STAFF REPORT

APPLICATION RZ/FDP 2001-MV-030

APPLICANT:	Landmark Properties Development, LLC
PRESENT ZONING:	R-2, CRD, HC
REQUESTED ZONING:	PDH-5, CRD, HC
PARCEL:	110-1 ((1)) 2
ACREAGE:	5.47 Acres
DENSITY:	4.57 du/acre
OPEN SPACE:	35%
PLAN MAP:	Mixed Use
PROPOSAL:	The applicant seeks to rezone the subject 5.47 acre site from R-2 to PDH-5 to permit the development of twenty-five (25) single family detached dwellings at a density of 4.57 du/acre.

ROUTE 1 NOISE FENCE

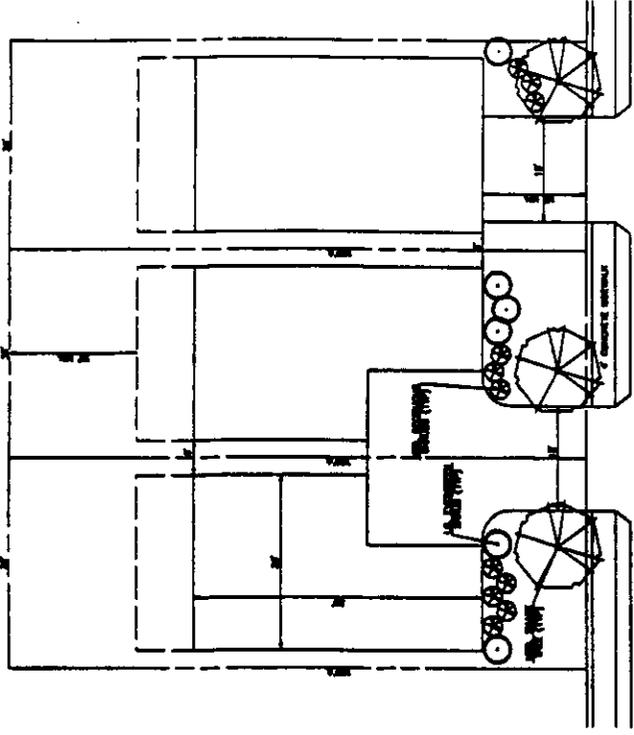
The applicant also requests a waiver of the fence height along the frontage of Richmond Highway to address exterior noise level concerns. Staff requested the applicant to provide a proffer to limit the exterior noise on the application property for lots 1-7 and 20-25 to an exterior noise level in accordance with the County's outdoor noise standards. The applicant currently depicts a noise wall along the rear yards of Lots 23-25. At this time, staff is unable to determine if the depicted noise wall will be able to completely address the County's outdoor noise standards. A noise study completed by the applicant may assist in a resolution to this issue. Staff has recommended a development condition which requires the applicant to demonstrate to the satisfaction of DPWES that the exterior noise for Lots 1-7 and 20-25 do not exceed 65 dBA Ldn.

The application also proposes to provide buffers, barriers and construction to address noise attenuation. Along the frontage of the property with Richmond Highway and extending down lots 23-25, the applicant is constructing a noise wall seven feet in height without gaps or openings. However, no specific commitment to reduce exterior noise to 65 dBA Ldn has been provided. Further, construction materials are being used with the homes closest to Richmond Highway in order to reduce the amount of interior noise to levels as suggested by Staff.

TYPICAL SINGLE-FAMILY LOT LANDSCAPING
SEE PLAN FOR SCALE

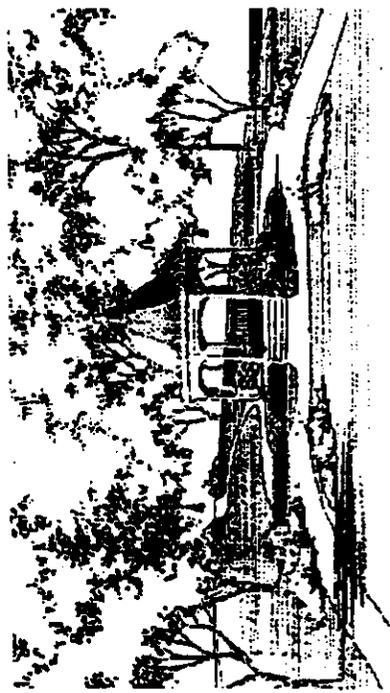
2. **Comment:** The development plan shows shade trees to be planted in the front yards of the lots, but there are ornamental trees shown on the typical lot layout, sheet 3 of 4. Additionally, there is insufficient room on the lots for shade trees.

TALBOTT PROPERTY
 EXISTING VEGETATION MAP
 MOUNT VERMONT DISTRICT
 FAYAL COUNTY, VERMONT

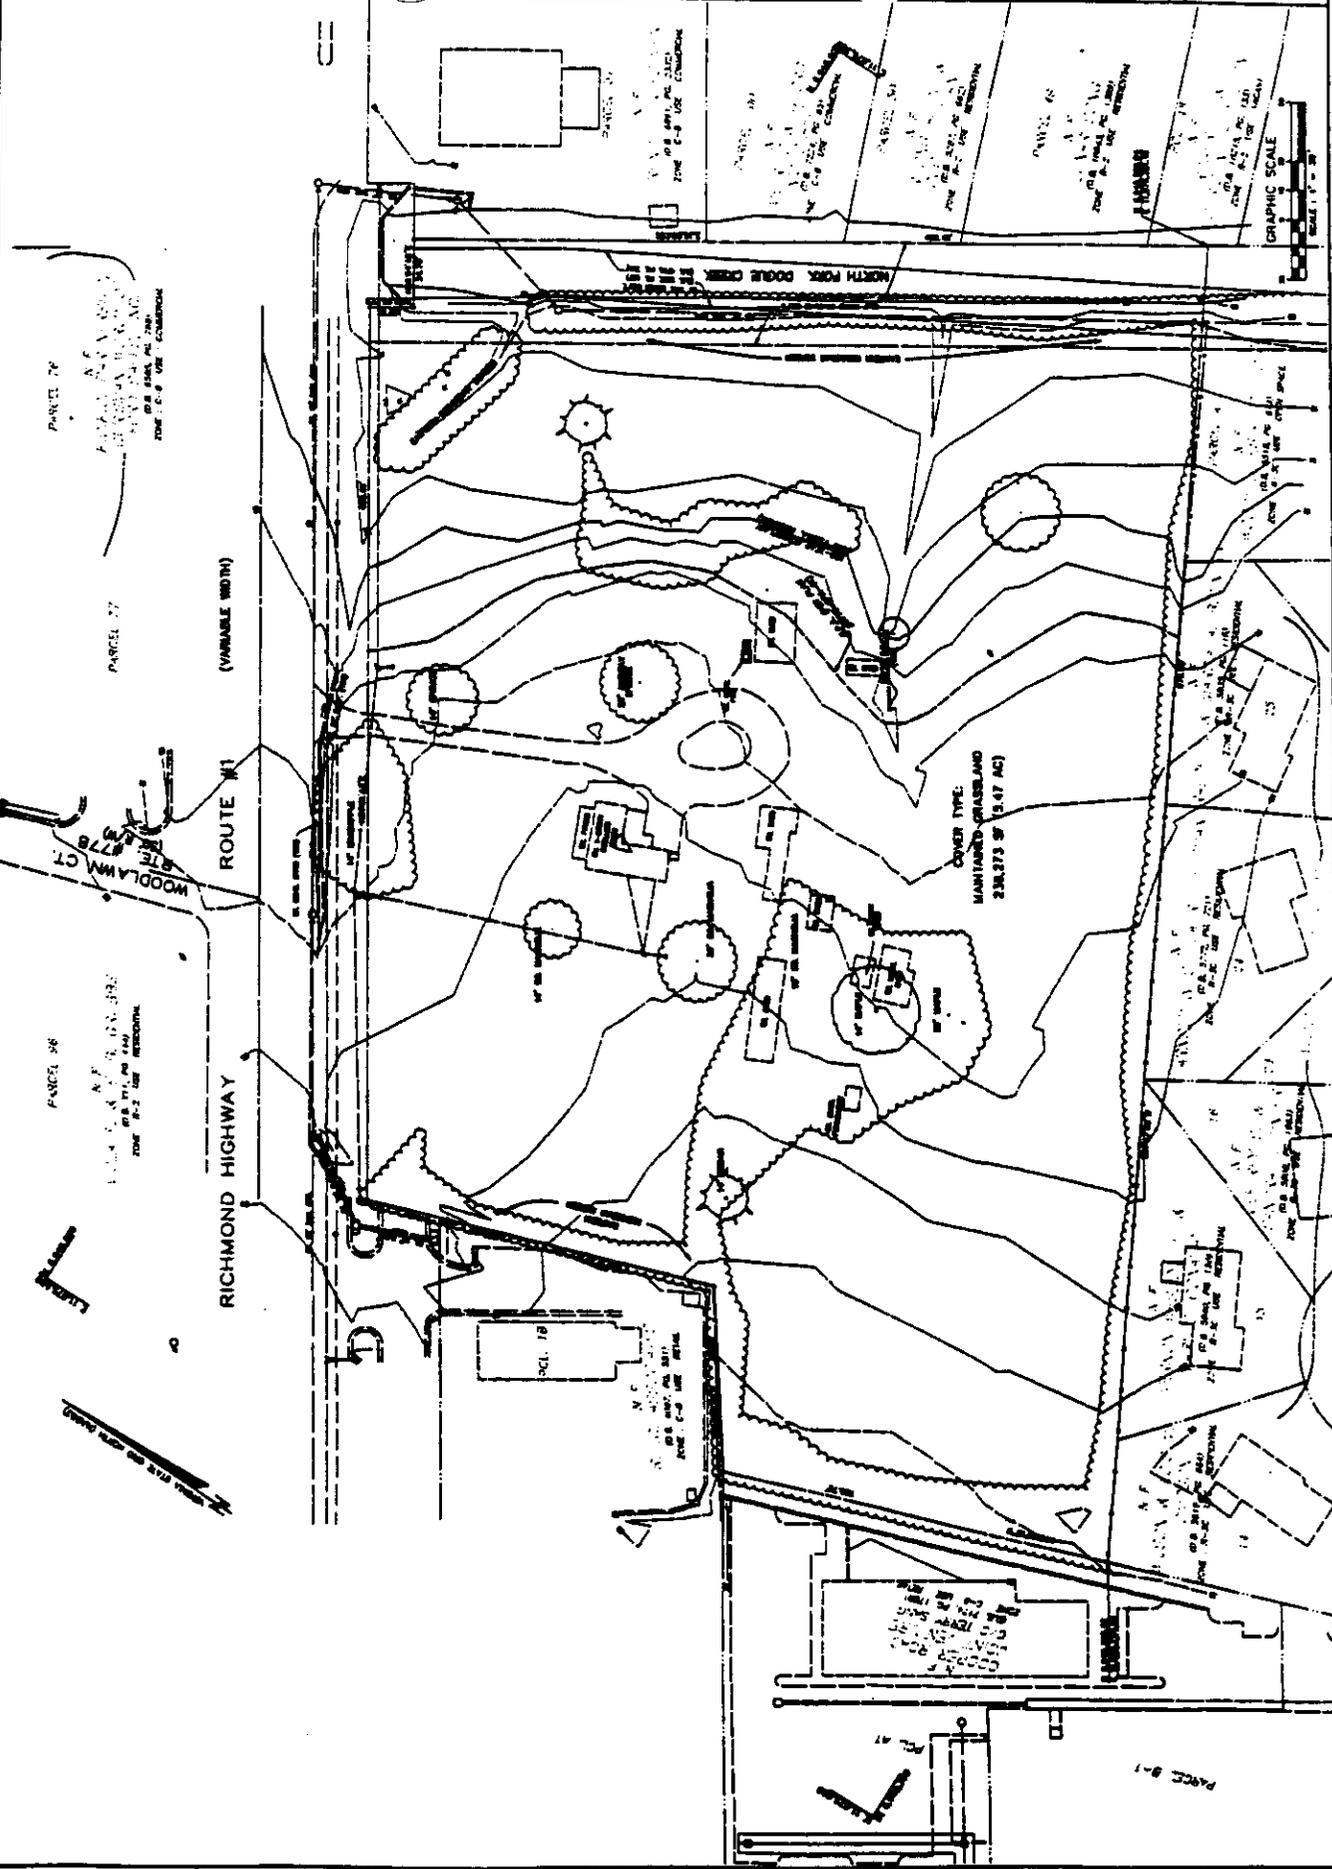
1. **Comment:** Previous comments recommended the preservation of a 30-inch diameter southern magnolia which is currently not planned for. There are other trees along the western property line that based on the current design could be preserved. Refer to the Existing Vegetation Map, sheet 4 of 4, on the development plan for locations of existing trees.
